RECEIPT DATE: 12/20/16 **ONSITE SEWAGE DISPOSAL SYSTEM** P 5-59883

PROPERTY ADDRESS: 13548 Mitchells Way W. Friendship, MD 21794

RE: 13548 Mitchells Way
West Friendship, MD 21794
"OSDS Plan"

I have reviewed the OSDS Plan for Cloverfield Sec. 1 Lot 8 and here are my comments.

ONSITE SEWAGE DISPOSAL SYSTEM
DESIGN PLAN AND PLOT PLAN
SPRING MILL LLC
13548 MITCHELLS WAY
TAX ACCOUNT NO.: 348830
LOT 8
CLOVERFIELD- SECTION I
3RD ELECTION DISTRICT * HOWARD COUNTY, MD.
TAX MAP: 15 BLOCK: 8 PARCEL: 4

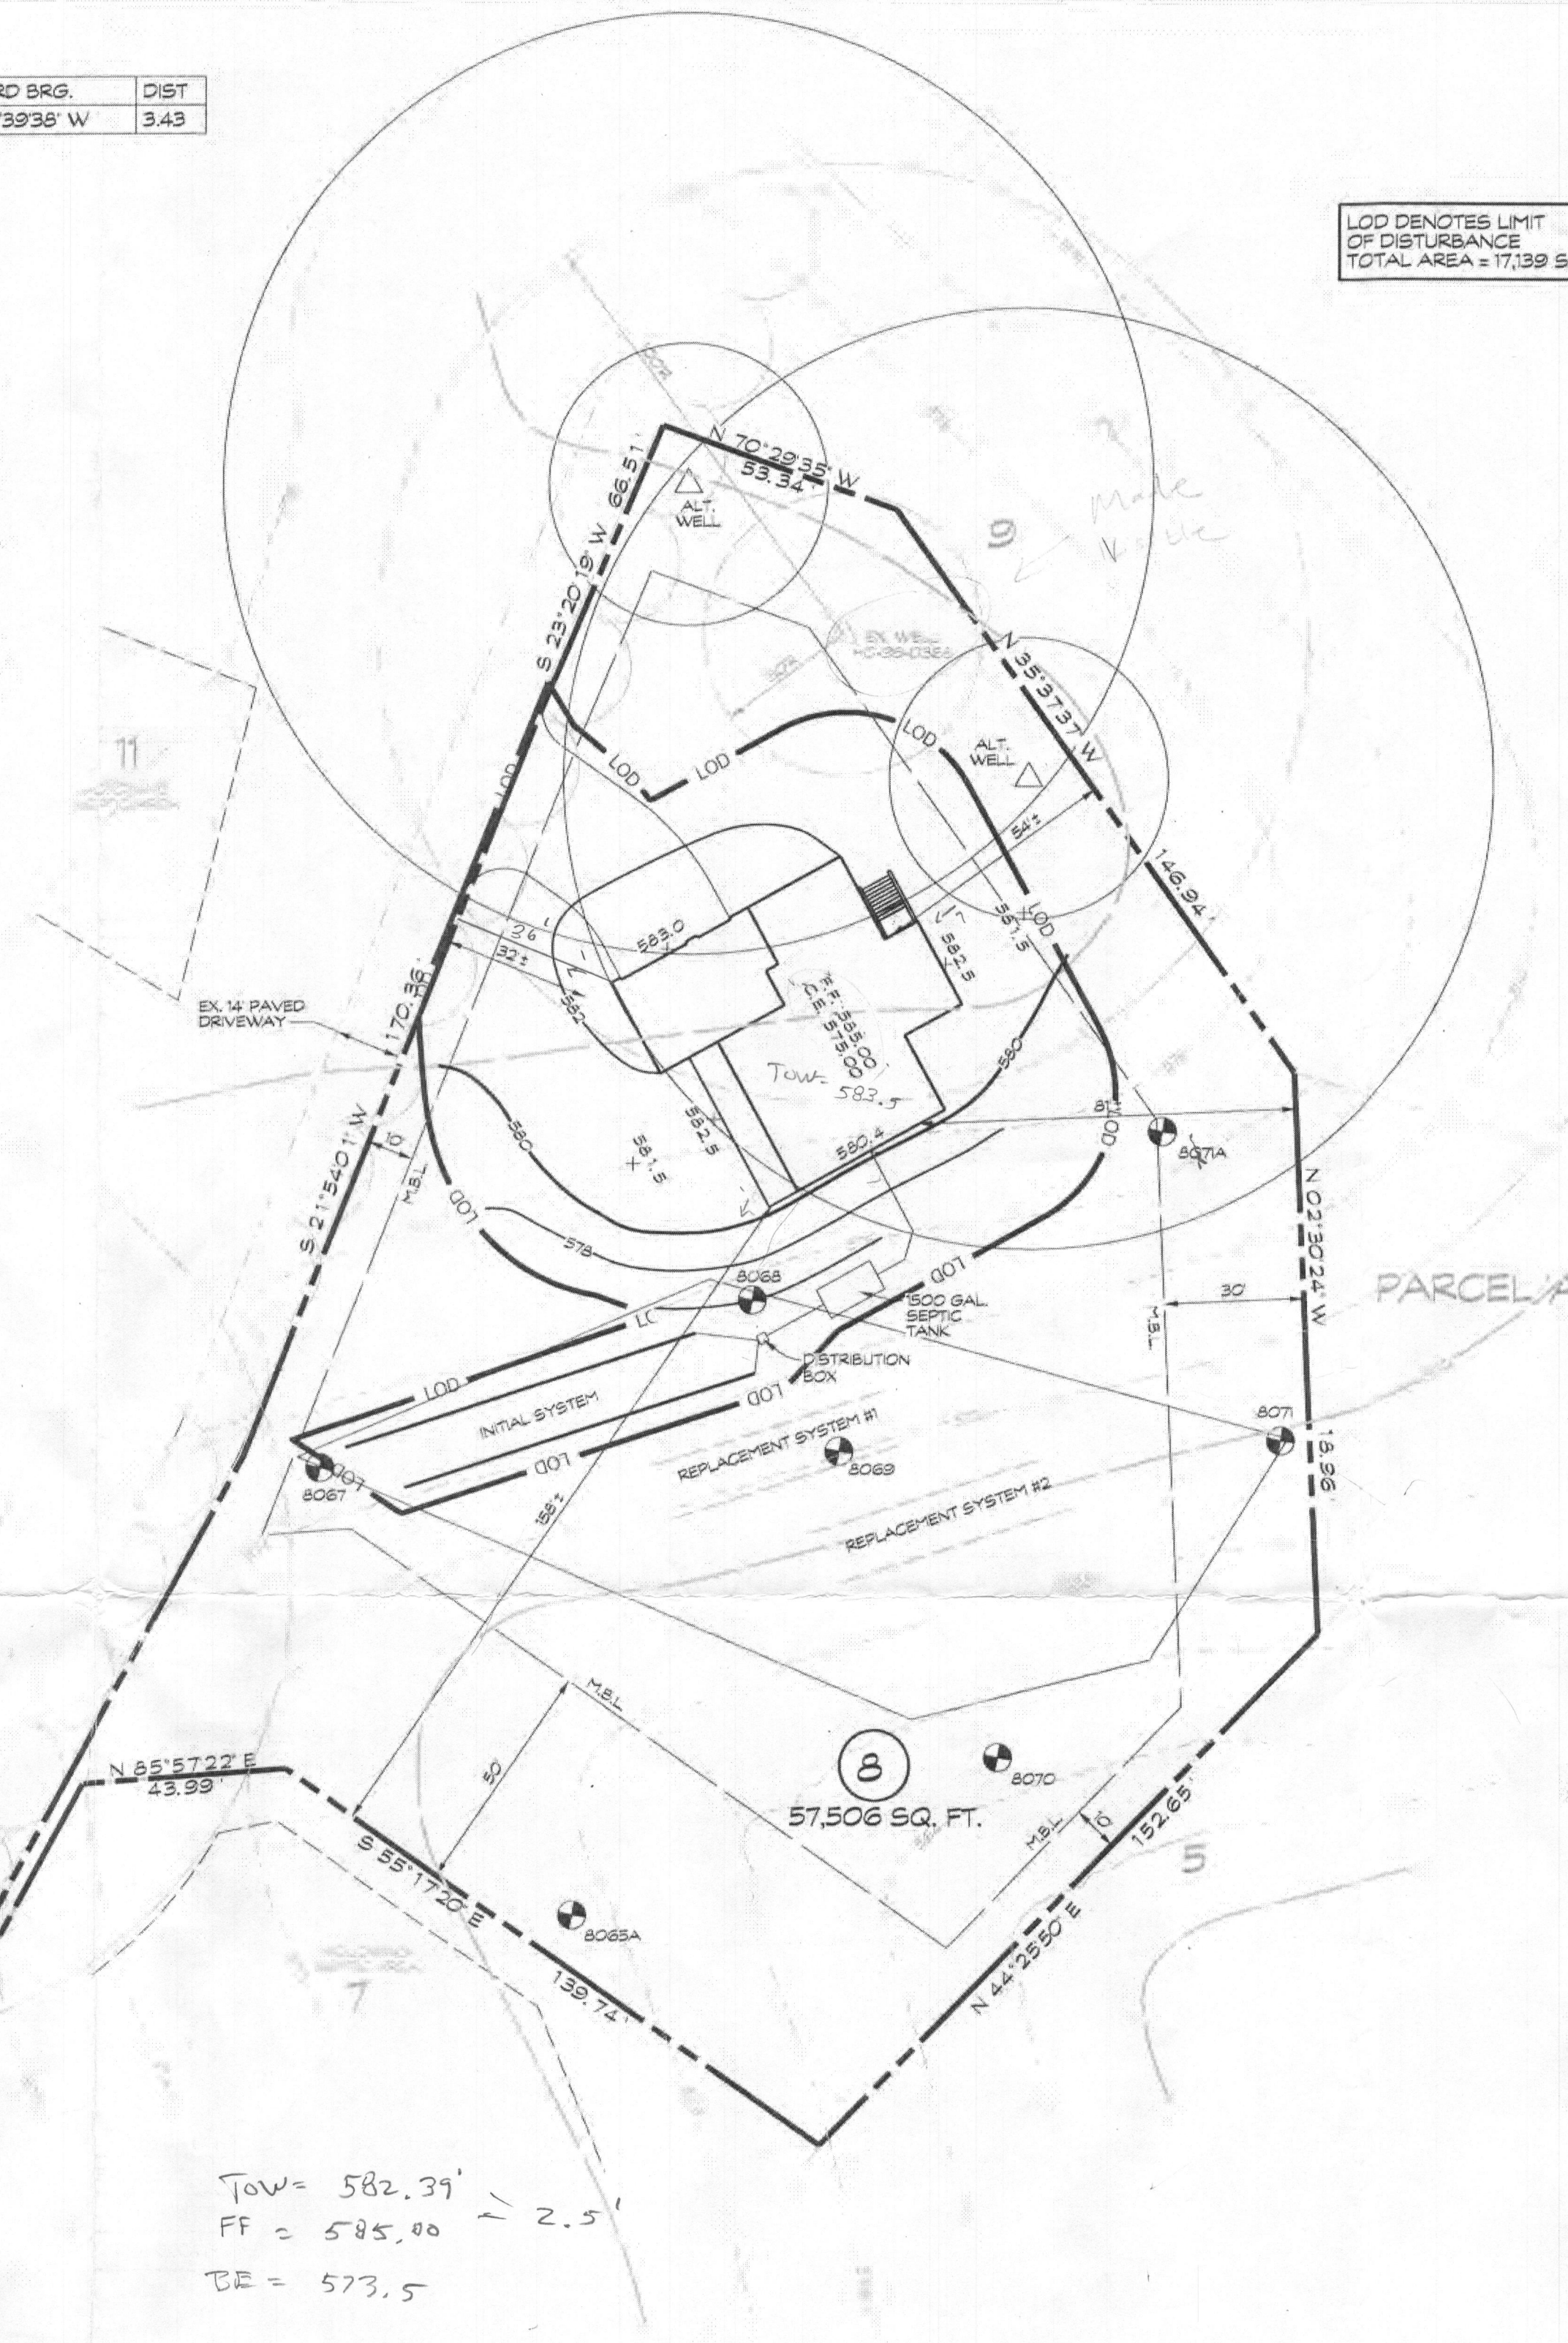
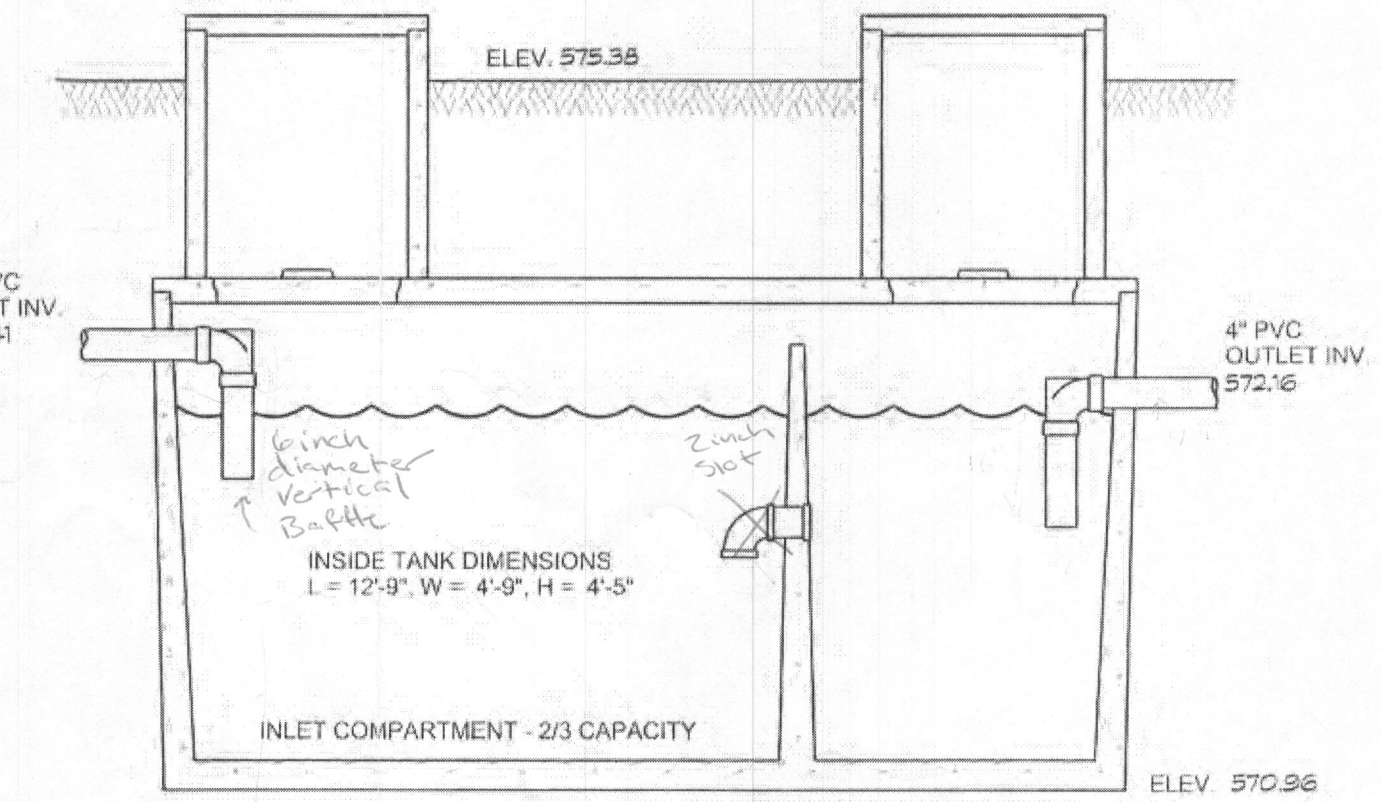
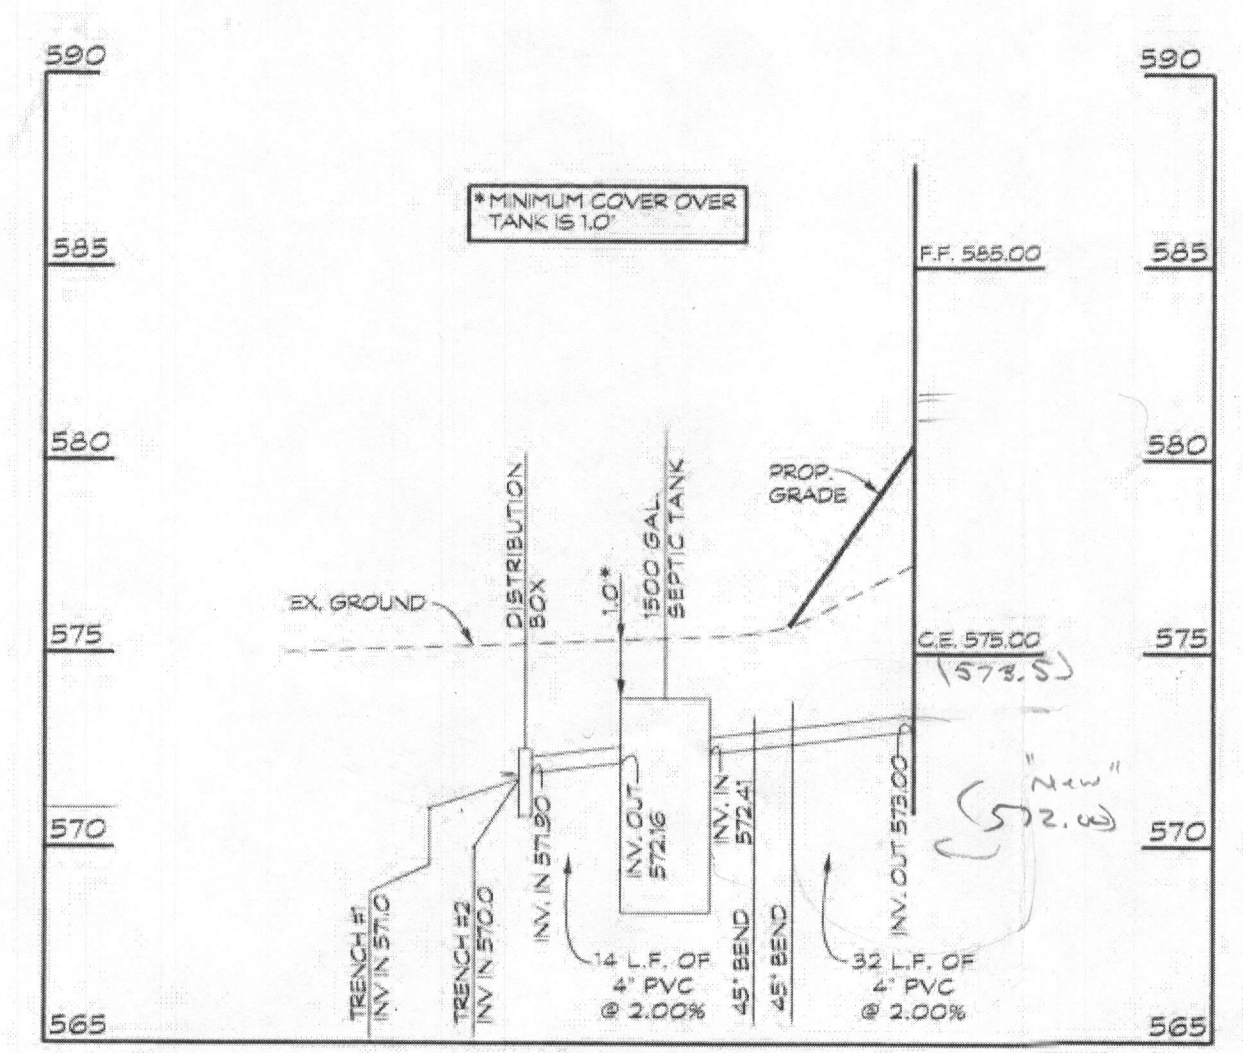
Hey Linda,
Instead of having new plans submitted for Cloverfield Lot 8 would it be ok with you if I red lined the plan for you? I would only need to red line the 2 inch slot in the septic tank and the inlet vertical baffle to a 6" diameter. Let me know if you have any questions. Thanks.

- The internal wall separating the two compartments cannot contain a baffle. There must be a 2 inch slot.
- The inlet vertical baffle must be 6 inches in diameter.
- Ex. Well needs to be visible.
- Relative replacement trench elevations need to be shown.

Date	Revisions	Drawn By
7/28/16	REVISED PER ROBERT FREEMAN EMAIL DATED 7/7/16	BM
12/8/16	REVISED BAT TANK TO SEPTIC TANK	LDA
		Date: 6/16/16
		Scale: AS SHOWN
		Job No.: 2013039
		Sheet: 1 OF 1
